Vanguard 7300 Series Controller Card Hardware Advisory Notice Boot Prom Instructions

This notice describes the new Vanguard 7300 Series controller card, 75836G01 revision D or greater and the boot prom required.

Figure 1. Board Assembly Number Label

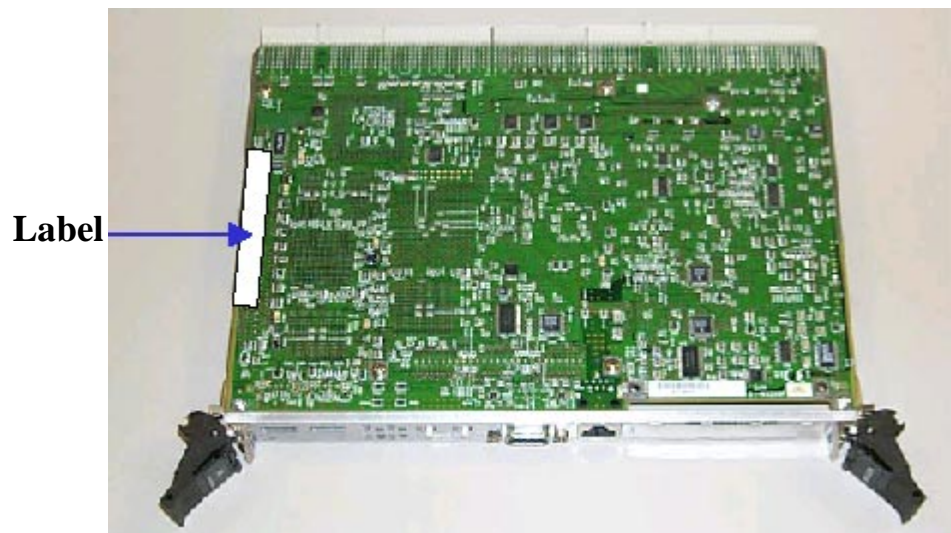
Any controller card numbered 75836G01 with revision D or greater **REQUIRES** the new boot prom code and must not be downgraded past 1.40.

Refer to Figure 1 to locate your board assembly number:

This new card is functionally equivalent to the original card, but does require new boot prom code and coldloaders to operate. This new boot prom code is release 1.40. A new CD and software version, 5.4P0LB was created to support release 1.40.

In order to prevent inadvertently loading boot prom revision 1.30 onto a new system controller card, please discard any CD's previous to the 5.4P0LB CD.
